Communities Against the Tunnels

Joint Submission to the North South Bypass Tunnel Environmental Impact Statement

April 2005

Figure 1. Variation of particle emission rate with applied power.

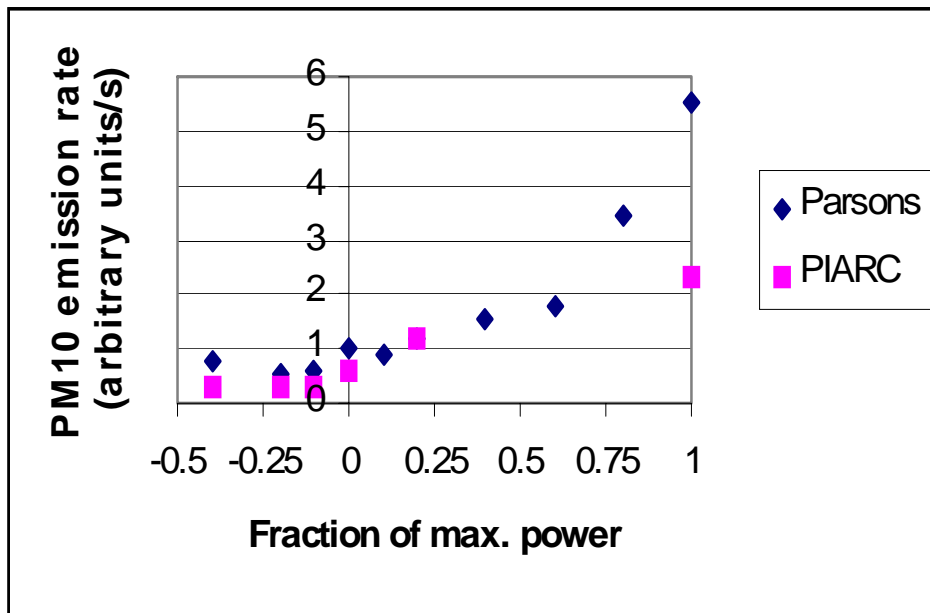
it is at full power. The PIARC data have been overlaid on the attached figure by putting the PIARC emission rate for zero grade and 60 kph equal to the Parsons results at 0.2P and the estimate for 6% grade at P=1. The PIARC estimates are effectively linear with power. The difference between the two sets of data will depend on how the PIARC data overlay the Australian results and the degree of non-linearity in the emissions as a function of engine power - this awaits further study.

In our view, it is quite possible that actual PM₁₀ emissions could be a factor of two or more higher than the PIARC estimates at full engine load as the majority of the emission will in fact, come from high power operation. It should be re-emphasised that this is new knowledge, not available to Hyder, but in view of the possible potential for exceedence this aspect needs to be taken into consideration.

Figure 2. Effect of heat transfer within a road tunnel. Vent flow = 800 m³/s,

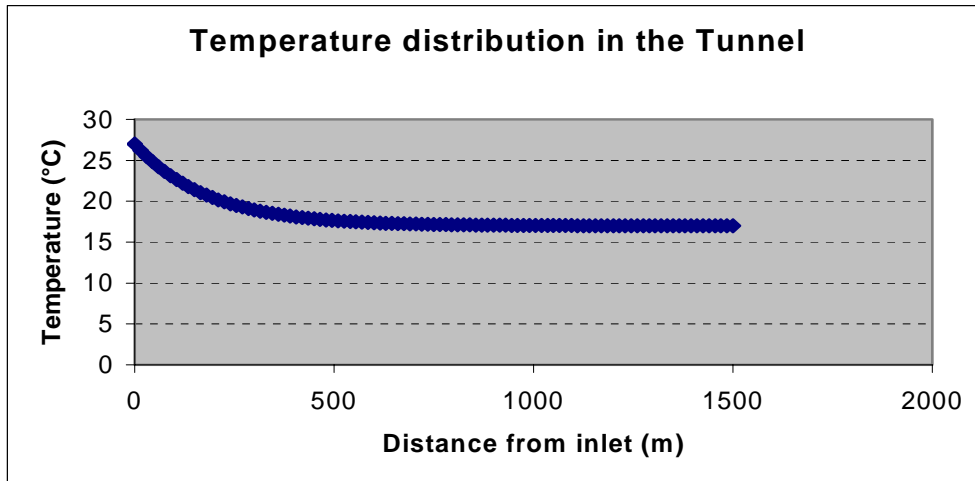
This buoyancy could enhance the effective stack height by 20 m or more. Whilst the reverse will be the case for summer afternoons, the higher dispersion rates, characteristic of neutral to unstable conditions at these times, means that the impact of negative buoyancy will be much less and also closer to the predictions of plume behaviour presented in the Hyder Reports.

As the degree of thermal buoyancy is proportional to the volume flow rate for a given temperature difference, it becomes quite small at the lowest fan speeds projected for minimum traffic flow so that there may well be only a small benefit for overnight plume strike conditions throughout the year.

Figure 6 Contour map of the maximum dispersion ratios based on measurements (at the sites indicated by dots) in the physical modelling of neutral flow conditions for the 35 m stack.

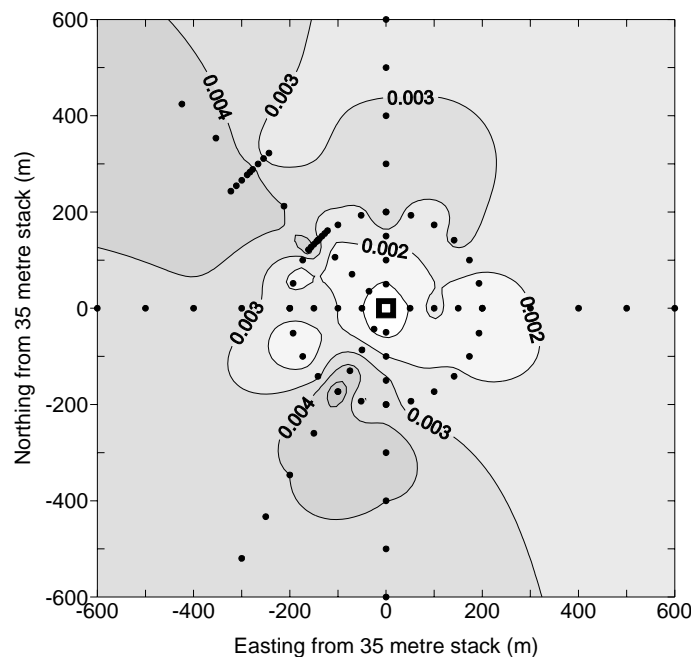
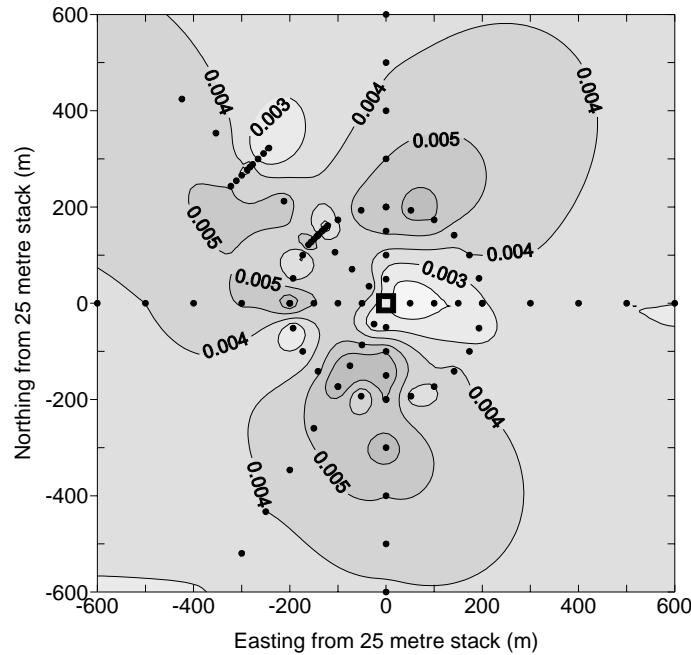
The overall quality of the presentation of the physical modelling results in the Hyder Reports is poor. There are over 200 pages of Figures in each Report showing results from each of the individual tests, but almost no summary plots other than Figure 8. In order to interpret the physical modelling results, contour plots of maximum dispersion ratios (Figures 6 and 7) have been extracted to determine the internal consistency and the influence of the topography. At each location, the maximum dispersion ratio has been extracted from the Figures in the Reports. Note that the contouring has been done to assist in visualising the results and no significance should be given to contour lines in regions where there are no data.

Both contour plots (Figures 6 and 7) show good internal consistency between the data measured in the various series for each stack, although the data for the 25 m stack appear to be slightly noisier. In both cases, the maximum dispersion ratios are observed 200–300 m downwind from the stack, possibly slightly further downwind for the higher stack. The peaks tend to occur on the hills to the north and south, as indicated by the topographic contours shown in Figure 5.

Figure 8. Comparison of maximum dispersion ratios for neutral and stable flow conditions as measured in the physical modelling for a southerly wind.

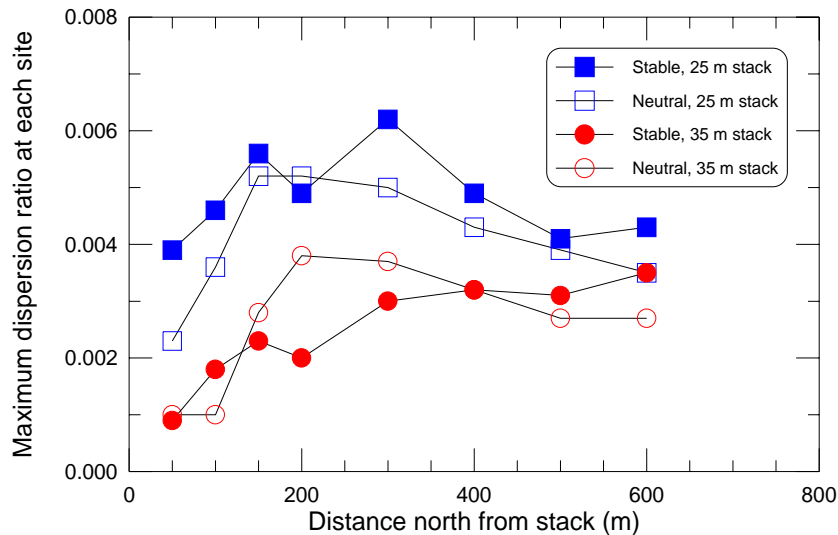
For the wind speeds and stack efflux velocities producing the highest dispersion ratios, the physical modelling showed remarkably little change in the maximum dispersion ratios at ground level when the flow conditions were changed from neutral to stable, as shown by our analysis presented in Figure 8. This is all the more surprising because the stability of 0.077 K m^{-1} used in the physical modelling is twice as large as that assumed in the corresponding mathematical modelling. This lack of influence of stability was not commented on in the report, although it has been explained in later communication with Hyder as being due to high low-level turbulence in the high wind speed conditions. It should be noted that at lower wind speeds and higher efflux velocities, the modelling results do show significantly lower glcs in stable conditions.

Some doubt about the reliability of the wind tunnel measurements in stable conditions is indicated by our analysis presented in Figure 9, which compares the vertical profiles measured 400 m downwind from the stack in neutral and stable conditions at the same efflux velocity and wind speed. Although the plume is not mixed to the ground as effectively in stable conditions, the figure shows that more of the plume is transported to higher levels in the stable case than in the neutral case. For the stack height of 35 m, the plume released into the stable environment is distributed more evenly between elevations of 25 m and 125 m, and the concentration at 125 m is more than five times greater than in the neutral case. This is counter to our expectation that stable conditions should inhibit vertical transport of the plume.

Figure 9. Comparison of vertical concentration profiles for neutral and stable flow conditions at sites 400 m downwind from the stack. The neutral profile was measured NW from the stack, and the stable profile due north of the stack.

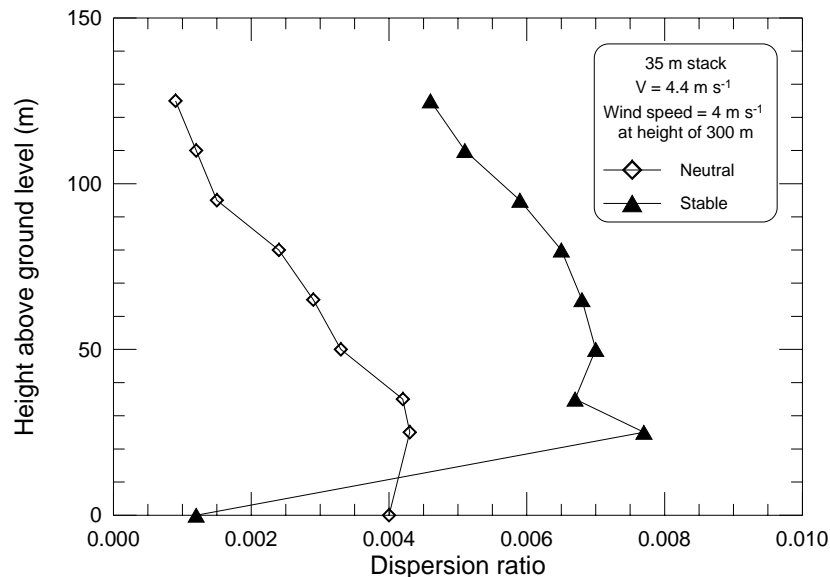
Moreover, a simple pollutant flux estimate using the concentration profiles in Figure 9 and assuming a power law velocity profile shows more than twice as much pollutant flux in the stable case as in the neutral case. The shapes of the upper parts of the concentration profiles also suggest that this difference would be greater if measurements had been made to higher elevations. If both profiles are on the plume centreline, there would need to be considerably more horizontal dispersion in the neutral case (against expectations) in order to match the pollutant fluxes in the two cases. This surprising result suggests a lack of consistency between the emissions for the two cases.

We conclude that the physical modelling for neutral flow conditions is close to reality for the modelled conditions. However, the lack of data for wind speeds below 4 m s^{-1} (equivalent to 2.7 m s^{-1} at 10 m above ground level) is a significant limitation of the physical modelling. In particular, it makes it impossible to compare the physical modelling with the mathematical modelling at the wind speeds as low as 1 m s^{-1} , which existed at the times of the highest glcs predicted by the mathematical modelling.

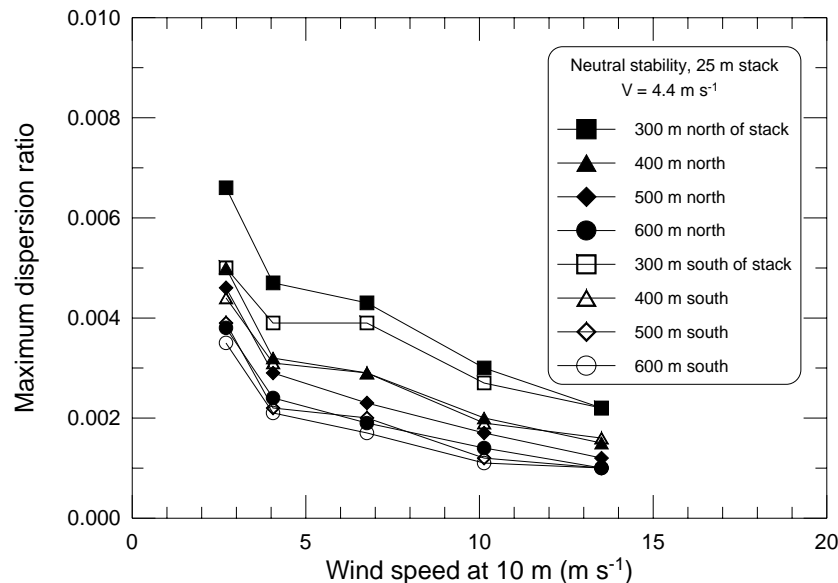
We conclude that with the data provided in the Hyder Reports it is impossible to make a valid comparison between the physical and mathematical modelling. This is in part because of the absence of physical modelling at wind speeds below 2.7 m s^{-1} for neutral conditions, and also because of the problems with the physical modelling of stable conditions. However, if the wind speeds, directions and stability classes corresponding to the maximum dispersion ratios for each efflux velocity (Table 4.1 of Part 3 of the Hyder Reports) were available, it may be possible to make a comparison for conditions for which both physical and mathematical modelling results were obtained. At present it is not possible to appeal to the physical modelling to prove that the numerical model predictions are conservative estimates of real-world conditions with the M5 East stack operating.

most likely that higher dispersion ratios occur at lower wind speeds. (Data from the physical modelling, Figures 18, 20, 22, 24, 50, 52, 54, and 56 of the Hyder Report for 25 m stack.)

Figure 11. Contour map of the ratio of maximum dispersion ratios for the 35 m and 25 m stacks for neutral flow conditions as determined by the physical modelling.

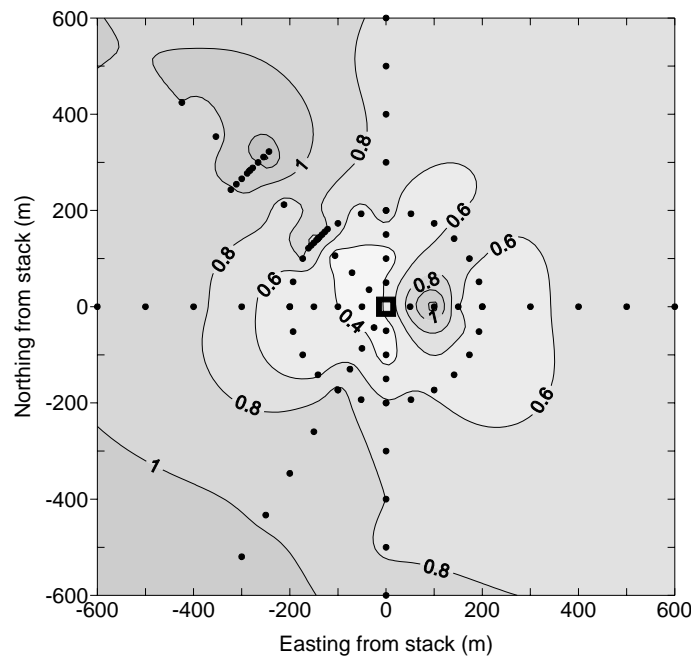
The effect of changing the stack height on the maximum dispersion ratios is shown in Figure 11 for the physical modelling. The Figure plots the ratio of results from the modelled 35 m stack to the modelled 25 m stack. Increasing the stack height from 25 m to 35 m generally reduces the concentrations by about 50% within 200 m of the stack (the exception 100 m east of the stack is probably due to an unfavourable combination of errors). The locations with slightly larger dispersion ratios (400 m NW and 600 m SW of the stack) correspond to elevated regions, and probably reflect an increase in plume impact. Note that these results are for neutral stability.

We conclude that with the stack exit conditions listed in the main Hyder Reports (2000a, b), the higher stack height (35 m) would be advantageous, especially given that conservative methods of including background NO₂ (hour-by-hour addition is not necessarily conservative), would increase the total NO₂ closer towards the air quality goals.

Figure 12. Sensitivity test of final plume height to stack exit velocity for the 35 m stack.

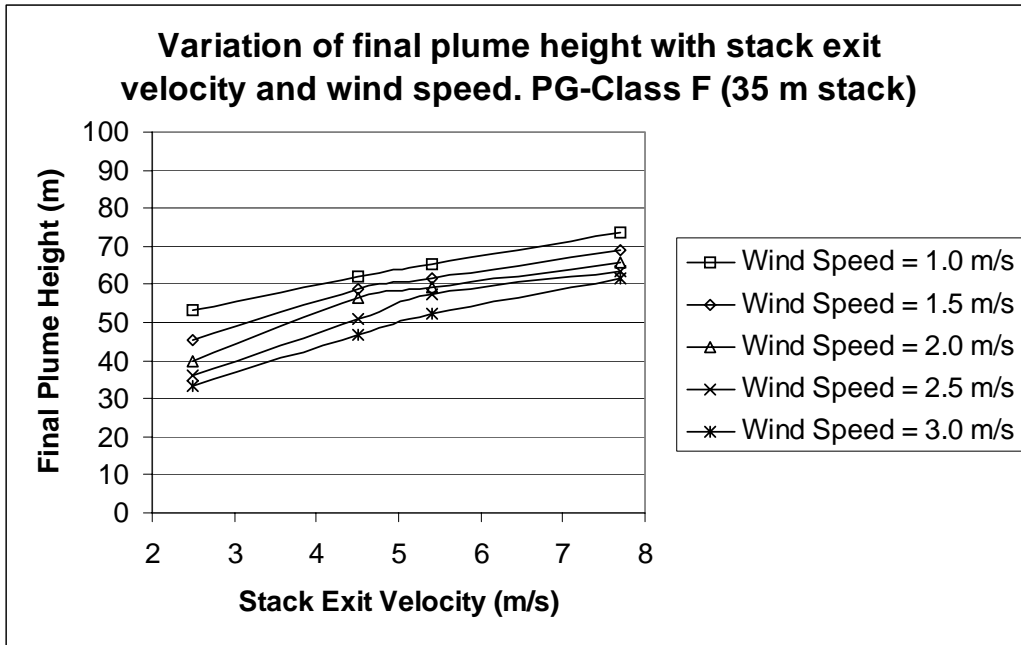
If stack exit velocity was increased for hours 21, 22 and 23 (currently 5.4, 4.5, 2.5 m s⁻¹ respectively), then ten (nine) of the top ten listed maximum stack concentrations, listed in the Hyder Report for a 25 m (35 m) stack, would decrease due to an increase in the effective plume height (see Figure 12). Note that stack-tip downwash is important when the ratio of the exit velocity to the wind speed at stack height becomes less than a ratio of 1.5, and this is predicted to be having a significant effect on maximum stack concentrations, particularly at hours 21–23.

The effect on maximum NO₂ ground level concentration of increasing stack exit velocity for hours 21 and 23 has been explored in the Hyder report (2000d) on air quality modelling for incident management. It was shown that by increasing the stack exit velocity from 5.4 m s⁻¹ to 9.0 m s⁻¹, the ground level concentration due to the 25 m stack for hour 21 on 29/10/95 was decreased from 169.1 to 111.6 µg m⁻³. When using the conservative maximum monthly background approach, this results in a cumulative concentration of 225 µg m⁻³. It was also shown that by increasing the stack exit velocity from 2.5 m s⁻¹ to 4.5 m s⁻¹, the ground level concentration due to the 25 m stack for hour 23 on 08/10/95 was decreased from 164.1 to 110.5 µg m⁻³. When using the conservative maximum monthly background approach, this results in a cumulative concentration of 224 µg m⁻³. These results illustrate that simply by increasing the stack exit velocity for certain night-time hours (e.g. hours 20-23), the air quality goals for NO₂ can be achieved, even for the 25 m stack, and when using a conservative approach to include background NO₂ concentrations.
